# Adamstown Boulevard

Stage 1 Road Safety Audit

Quintain Developments Ireland Ltd.

**Figure 2-1 – No Pedestrian Crossing Provision**

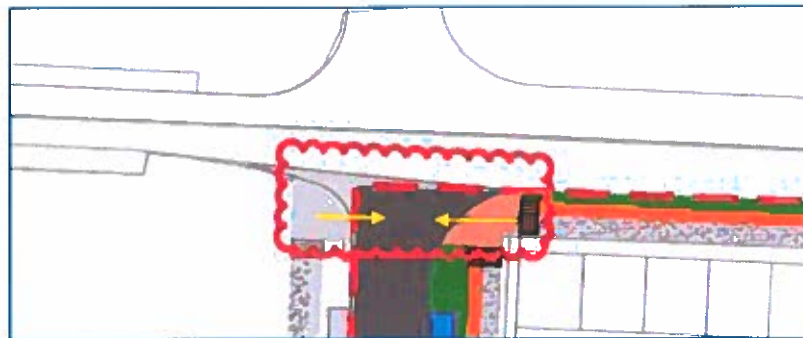
There is no crossing provision for pedestrians trying to cross East – West at the location shown in Figure 2-1. This may lead to pedestrians trying to cross the road in a location which is unsafe to do so and may result in them being struck by a vehicle.

The designer should provide appropriate crossing facilities for pedestrians to cross at the junction.

Figure 2-4 – Example of Grass verges Separating Footpath and Parking Bays

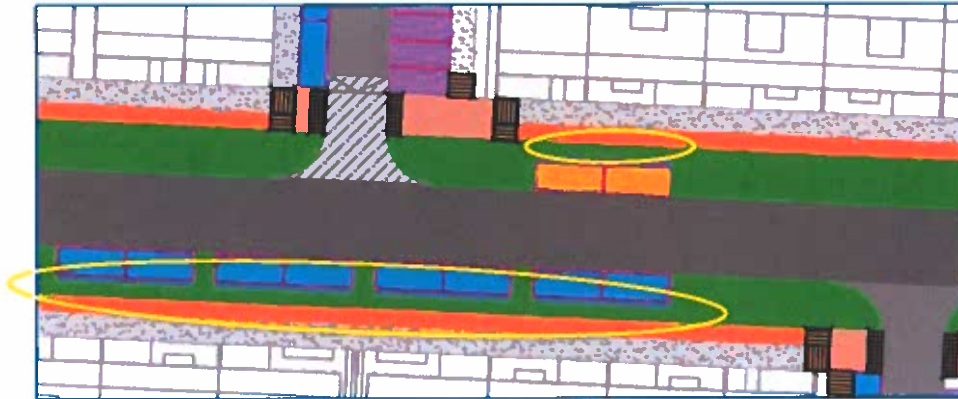
The proposed scheme shows parking bays which are separated from the footpath with a grass verge as shown in Figure 2-4. This could lead to pedestrians slipping and falling on the grass particularly in wet conditions or pedestrians may be forced to use the carriageway to access the parking spaces and possibly result in them being struck by a vehicle.

The designer should ensure that safe access to all parking areas is provided throughout the scheme.

**Figure 2-6 - Signalised Junction No. 2**

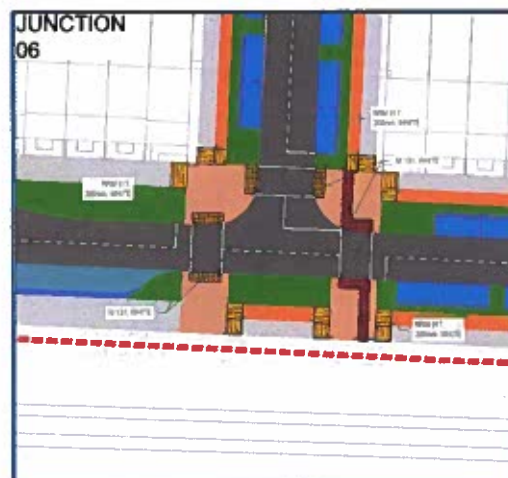
The proposals indicate courtesy crossings on the main north-south streets for the scheme. It appears unlikely that these will adequately allow for safe crossing of these roads and may lead to conflict with pedestrians and vehicles. Additionally the side road shows a controlled crossing, drivers may move on a green signal on the side road and enter the main road when it is unsafe to proceed. This may lead to shunt and side-impact conflict.

The designer should review the junction strategy ensuring these will cater for the likely demand, provide adequate control and not lead to potential confusion for both pedestrian and vehicles users.

**Figure 2-8 - Visibility Issue Location No.1**

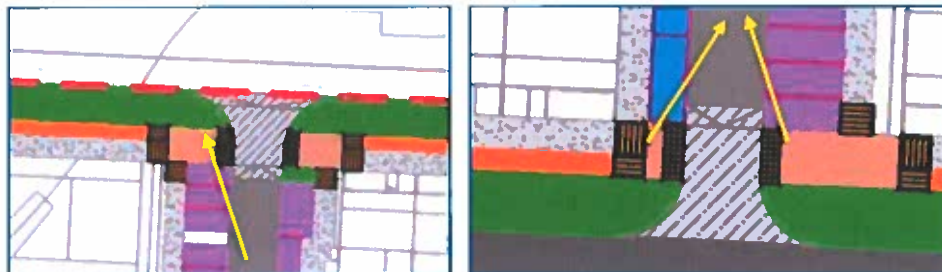
A number of proposed uncontrolled crossings will likely have visibility issues due to parked vehicles directly beside the crossing points. Footpath users particularly smaller individuals including children are unlikely to be able to see vehicles and similarly vehicles will be unable to see children that are attempting to cross. Poor visibility may lead to pedestrians trying to cross the carriageway without being sure it is safe to do so and could lead to them being struck by an oncoming vehicle.

The designer should relocate/set-back the parking to help improve visibility at the proposed uncontrolled crossings.

Paragraph No. in Safety Audit Report	To be completed by the Designer			To be completed by the Audit Team
	Problem accepted (yes/no)	Recommended measure accepted (yes/no)	Alternative measures (describe)	Alternative Measures accepted by Auditors (yes/no)
2.1	Y	Y		
2.2	Y	Y		
2.3	Y	Y		
2.4	Y	Y		
2.5	Y	Y	Parking to be adjusted to take account of appropriate visibility splay for the design speed of the road in accordance with DMURS	
2.6	Y	Y	Demand for crossing to be assessed an if required appropriate crossing provision provided.
